UNITED STATES PATENT AND TRADEMARK OFFICE

Office Action Summary

09/909,715

DETAILED ACTION

FIG. 5

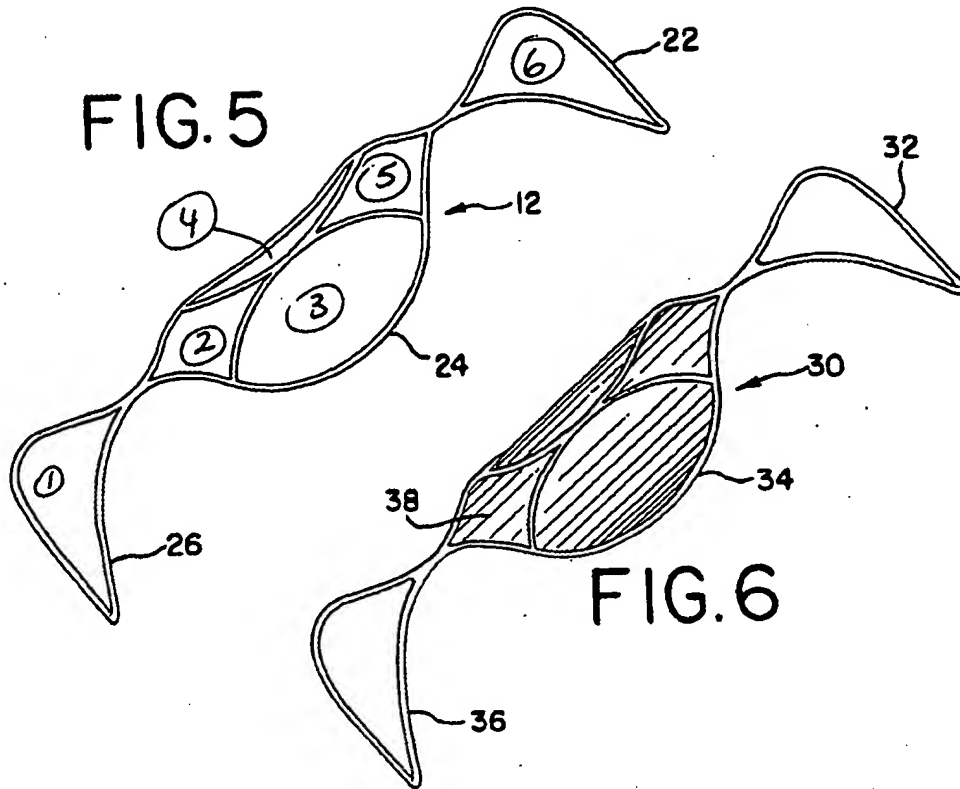
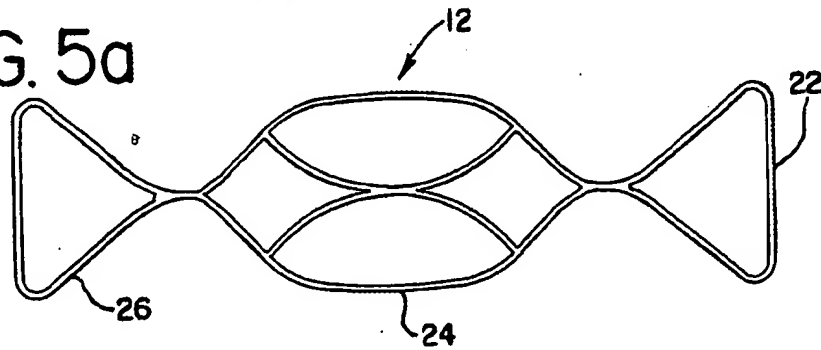
2. Claims 95-100 are rejected under 35 U.S.C. 102(e) as being anticipated by U.S. Patent No. 6,613,074 B1 to Mitelberg et al. Mitelberg discloses an apparatus for treating vascular aneurysms including six fenestrations, i.e. windows or openings, as labeled in Attachment A. The body of the stent is cylindrical and blood flows through the internal lumen. A reactive material (hydrogel) [column 5, lines 32-33] is applied to fenestrations 2-4 ("not all"), as shown in Figure 6. Hydrogels react in the presence of liquids, in this case blood. Hydrogel (38) "is intended to significantly reduce...the flow into the aneurysm" [column 5, lines 26-29]. In other words, applying a hydrogel to the fenestrations increases the resistance of blood flow through the fenestrations (compared to naked frame shown in Fig. 5), but *still allows some blood to flow into the aneurysm*. Mitelberg's stent is radially expandable to be the size of the interior lumen of the blood vessel [Column 2, lines 38-39]. Mitelberg's hydrogel expands with the stimulus of being exposed to a liquid (blood).

Fenestrations
①②③④⑤⑥
